Subject: Minutes for 51st Protection Sub-Committee Meeting.

51st Protection Sub-Committee Meeting (23rd July, 2024)-MoM

**Minutes of
51st Meeting of Protection Sub-Committee (PSC) of
Northern Regional Power Committee**

DR of 220 kV Kishenpur(PG) -Sarna(PS) (end) (PG) Ckt-2

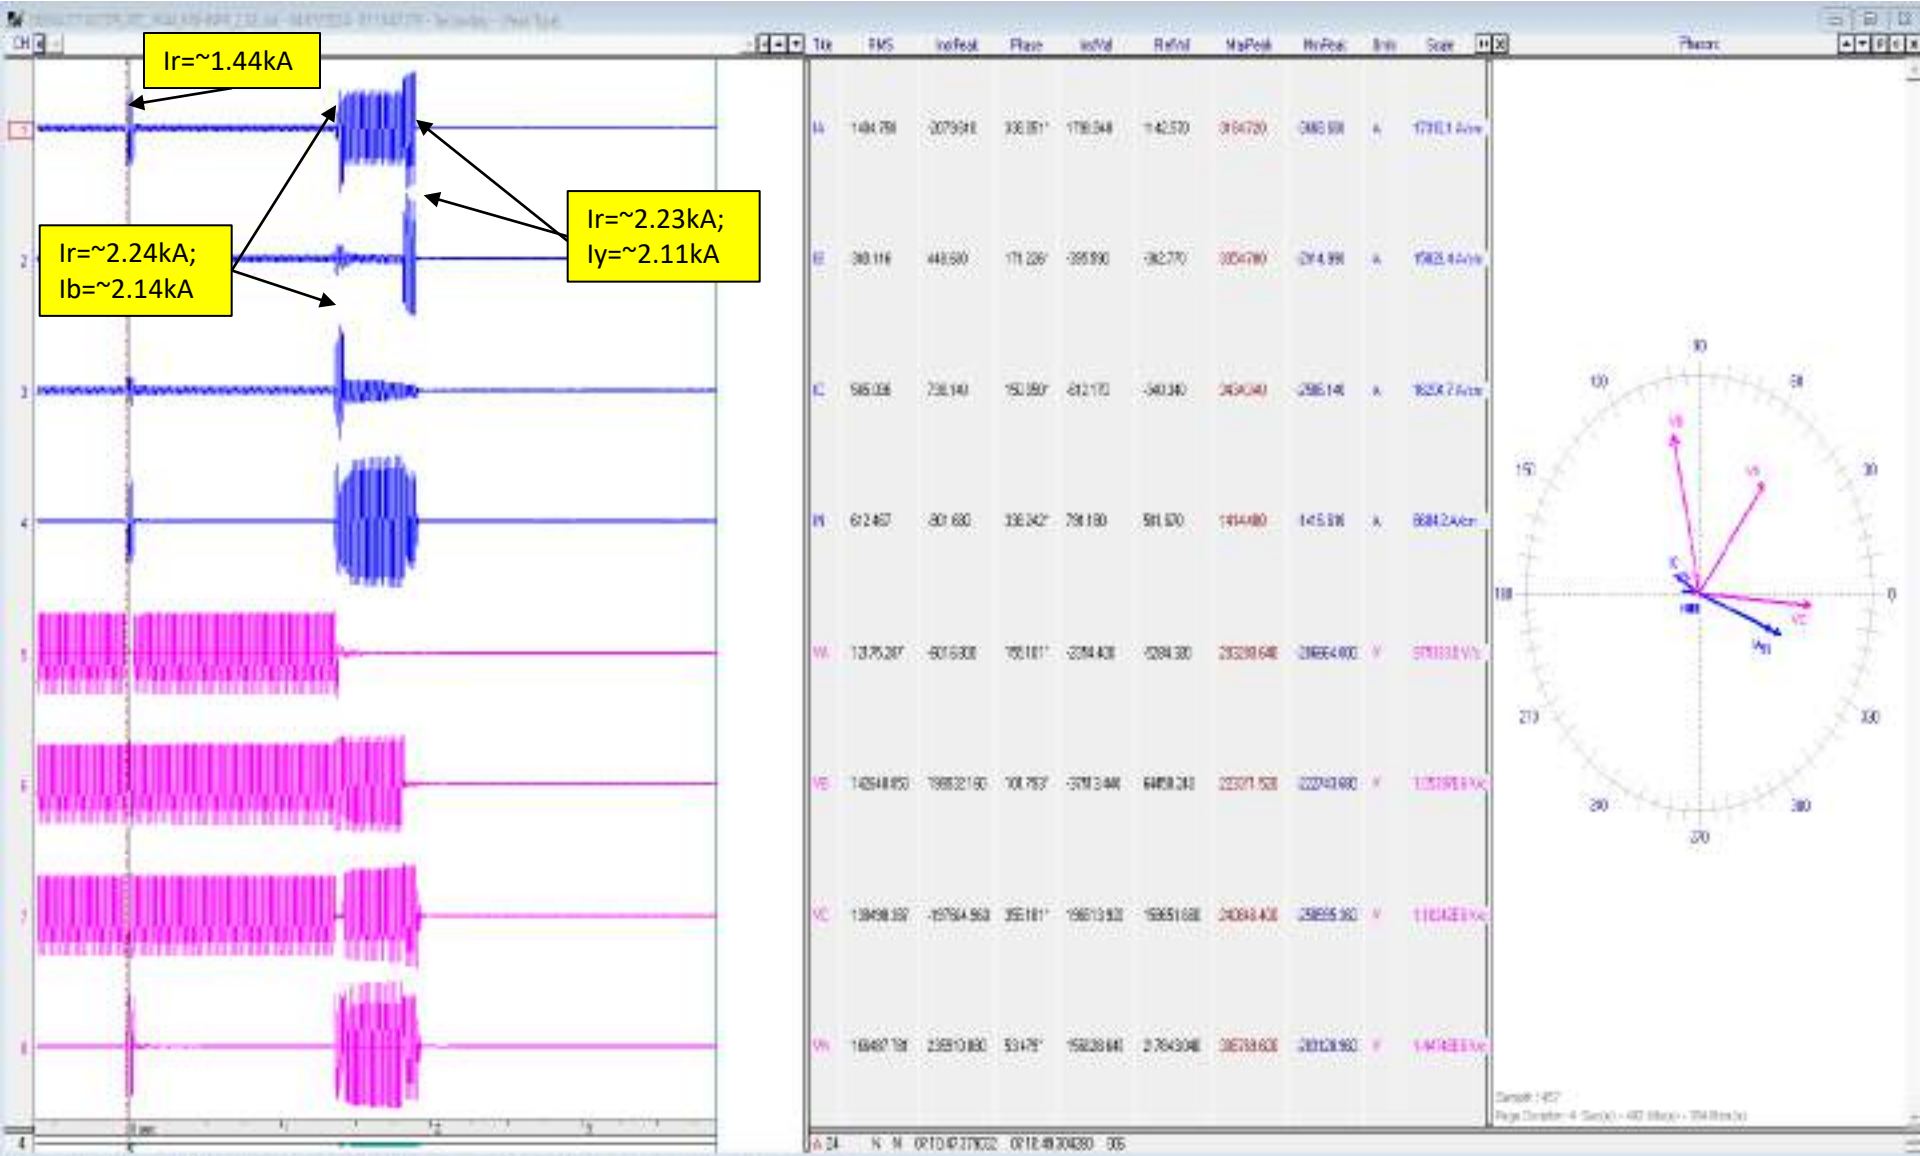
- ✓ R-N phase to earth fault followed by R-B-N double phase to earth fault converted to R-Y-N double phase to earth fault
- ✓ Zone-4 operated after a delay of ~540 ms at Sarna(PS) end
